NAVIGATION - STALL WARNING HORN REPLACEMENT FOR CESSNA MODELS 182, U206, 207

The original stall warning horn is no longer available. If the stall warning horn needs to be replaced a new stall warning horn and bracket are available.

SEB-34-32  
Page 1 of 9

Figure 1. Before Modification (Sheet 1)

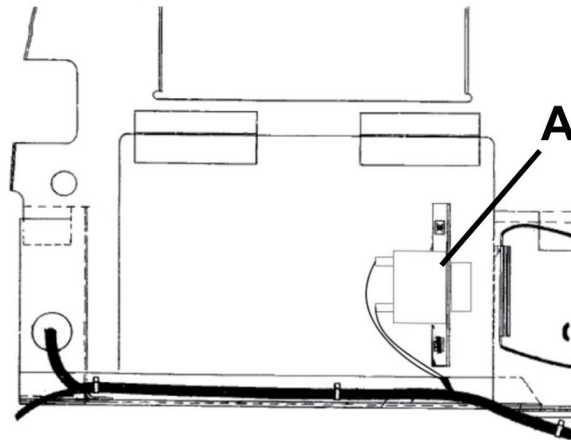
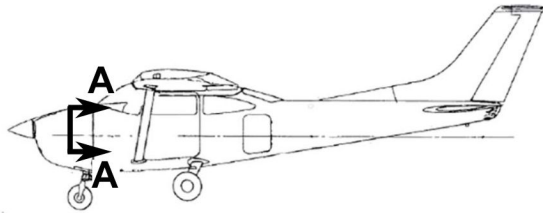
3. (Refer to Figure 1, Sheet 1.) Remove the 1670056-6/-7 Stall Warning Horn as follows:

- A. Remove and keep the two mounting screws from the 1670056-6/-7 Stall Warning Horn.

- B. Remove the nuts and washers from the studs of the 1670056-6/-7 Stall Warning Horn.

- C. Disconnect the electrical wiring from the 1670056-6/-7 Stall Warning Horn.

- D. Discard the 1670056-6/-7 Stall Warning Horn and the 0713738-3 Bracket Assembly.

Figure 2. After Modification (Sheet 1)

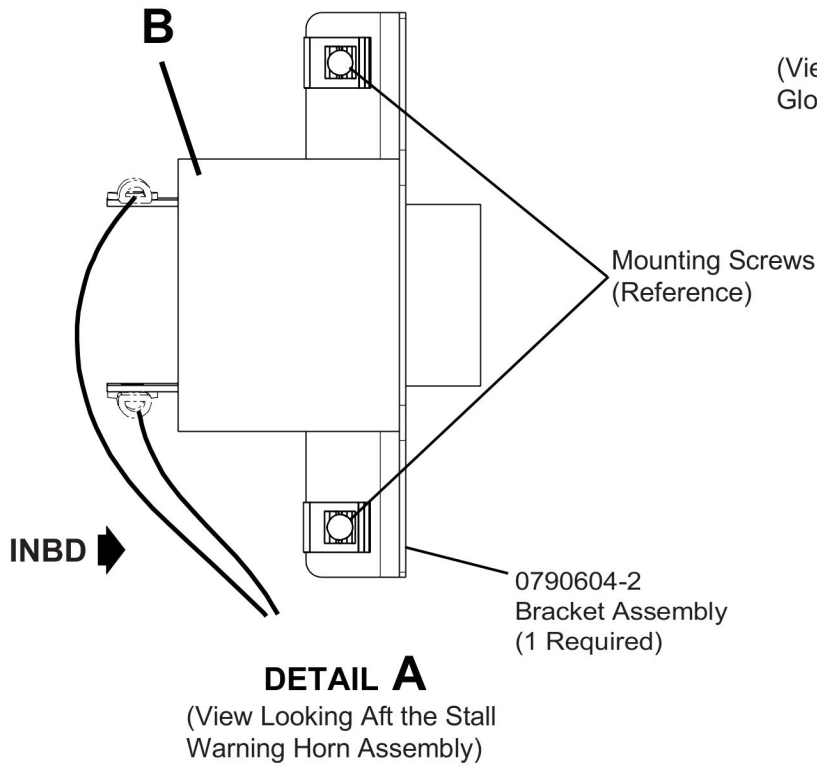
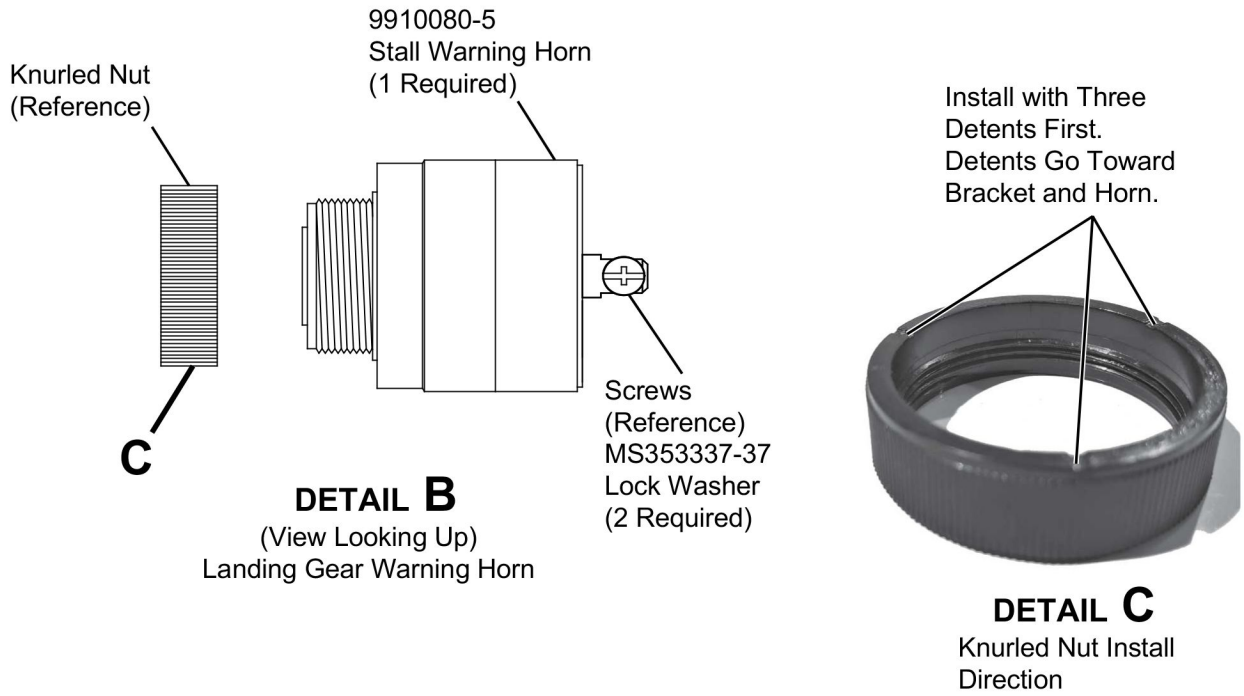
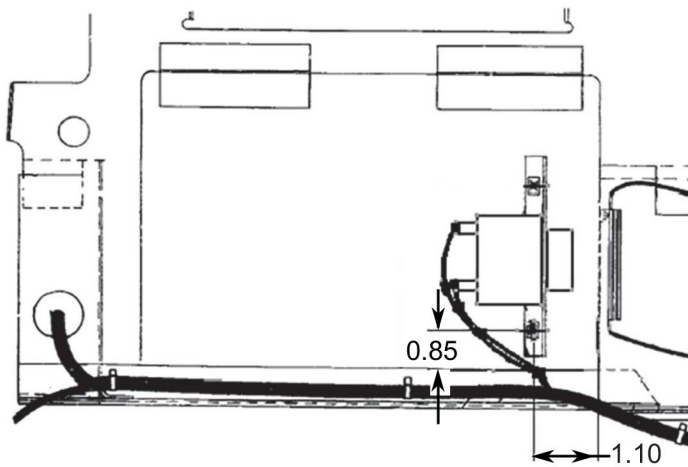
4. (Refer to Figure 2, Sheets 1 and 2.) Install the 9910080-5 Stall Warning Horn as follows:

**NOTE:** All installations of the 9910080-5 Stall Warning Horn will be mounted onto the forward side of the glovebox assembly.

- C. Install the 9910080-5 Stall Warning Horn into the 0790604-2 Bracket Assembly.

- D. Install the knurled nut onto the 9910080-5 Landing Gear Warning Horn.

**NOTE:** The plastic knurled nut must be installed with the three indents toward the bracket and horn assembly. On the internal circumference, the smooth side without threads is installed first, towards the bracket and horn. This technique of installation will make sure the nut fully seats against the bracket and not bottom-out on the threads. If not installed correctly the knurled nut will bottom-out on the threads and the horn assembly will not be fully tightened in the bracket.

- E. Install the 0790604-2 Bracket Assembly with the two kept mounting screws onto the glovebox assembly.
- F. Install the electrical wiring with one MS35333-37 Lock Washer onto each terminal of the 9910080-5 Stall Warning Horn.

Figure 3. Drilling Dimensions (Sheet 1)

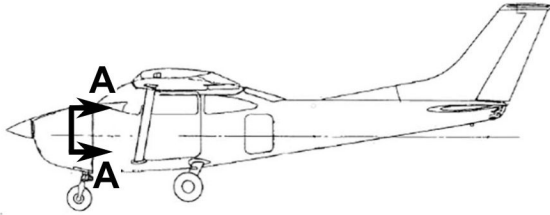
- B. (Refer to Figure 3, Sheet 1.) Match drill the two holes of the 0790604-2 Bracket Assembly to a Number 26 (0.147 inch diameter) holes into the glovebox assembly.

(1) Deburr the drilled holes.

(2) Apply Color Chemical Film Treatment to all bare metal.
